City of Portland
Bureau of Development Services
Land Use Services Division

Notice of a Type II Decision of an Appeal to reverse the original decision of denial and APPROVE a Proposal in Your Neighborhood

CASE FILE NUMBER: LU 08-122163 DZ, BANNER BANK ATM

The applicant requests design review for the removal and replacement of one concrete base panel directly north of the NW 10th Avenue entrance to the Burlington Tower building located at the northeast corner of NW 10th Avenue and NW Kearney Street. The existing concrete base panel will be removed as one piece and securely stored at a specified on-site location. A new concrete panel will be fabricated to match the existing building base in both color and material. A new ATM, serving a branch of Banner Bank recently approved under design review case LU 07-185754 DZ, will sit within the new concrete panel. The original concrete base panel will be reinstalled if the ATM is ever removed.

BANNER BANK - PEARL DISTRICT BRANCH
DR3 064500 04.14.08

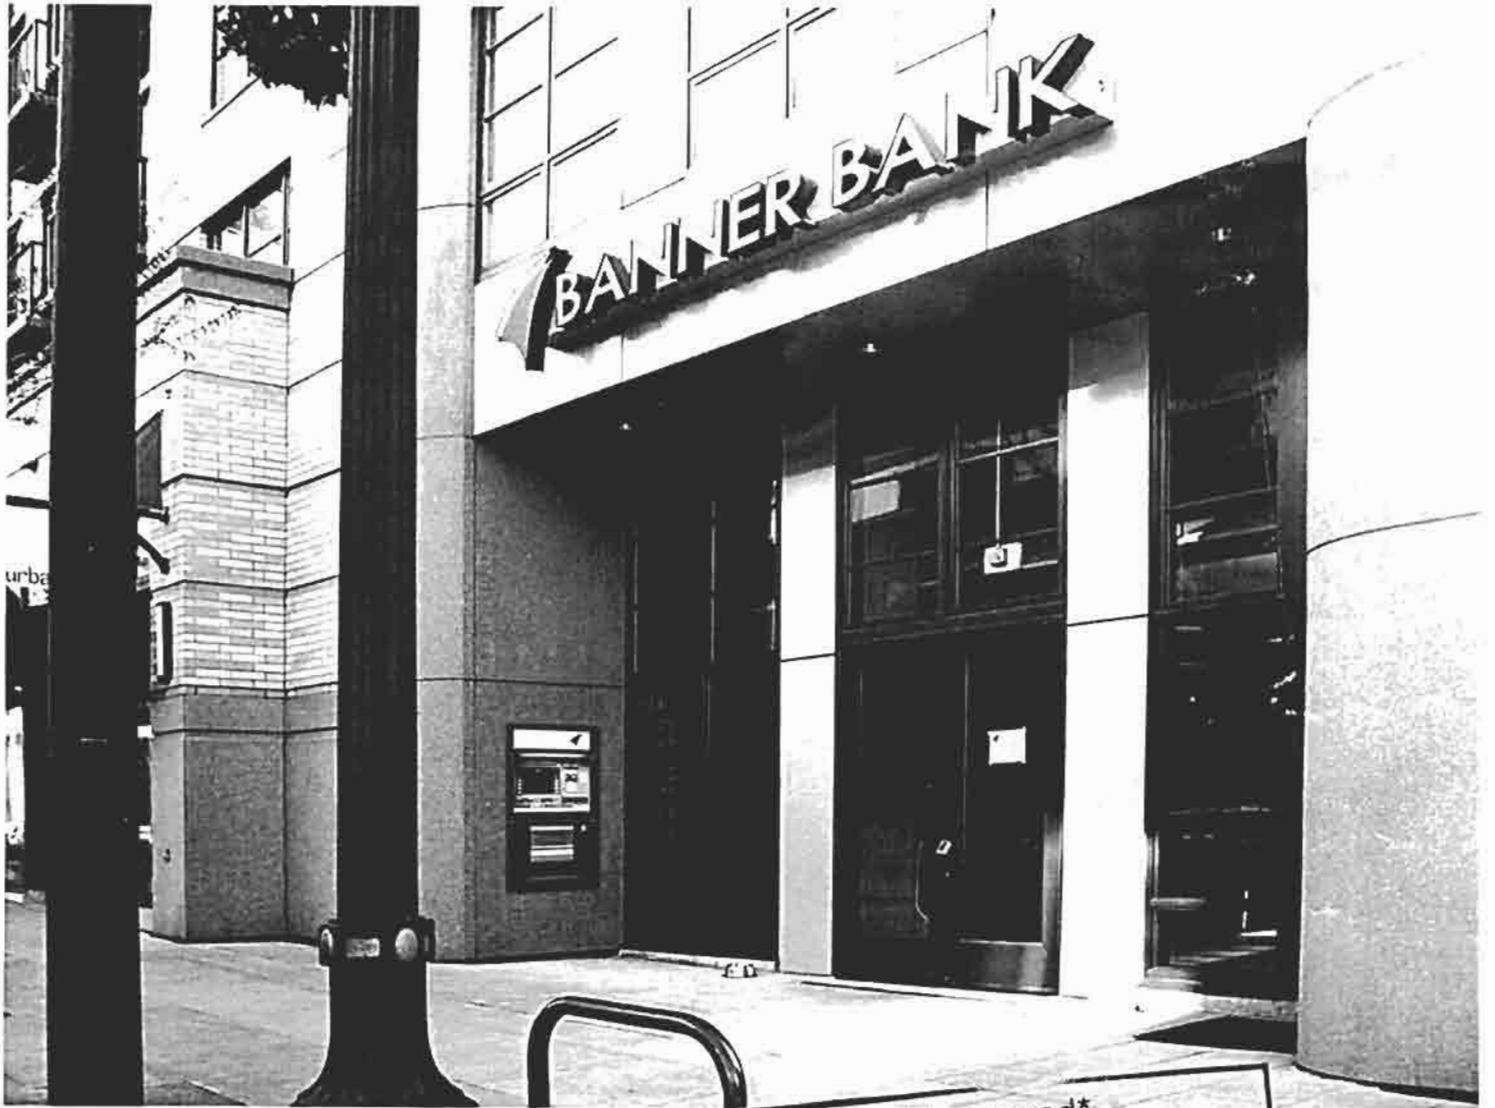
Findings: The location of the ATM near the bank’s main entrance, visible from the sidewalk is in keeping with other district ATM’s. The new ATM will sit within the opening in

the new concrete panel. Trim flanges will completely cover the panel opening and the face of the machine will project in front of the panel, similar to other ATM's in the area. *This guideline is therefore met.*

- the revised proposal for a concrete replacement panel fabricated and installed on the inside face of the concrete entry frame, directly north of the Banner Bank entry;
- the location of the ATM within the new replacement panel;
- removal and storage of the existing concrete base panel;
- re-installation of the stored panel when the ATM is removed.

- A. Applicant to provide a letter documenting the on-site storage location of the existing concrete panel and designating the building owner as responsible for replacement of the panel if the current tenant leaves.
- B. Applicant to provide a material sample of the replacement panel that will be reviewed and approved by design review staff. The sample will remain as part of the file record.
- C. Conditions A and B must be complete prior to issuance of a building permit.
- D. As part of the building permit application submittal, each of the 4 required site plans and any additional drawings must reflect the information and design approved by this land use review as indicated in Exhibits C-1 through C-6. The sheets on which this information appears must be labeled, "Proposal and design as approved in Case File # LU 07-122163 DZ. No field changes allowed."
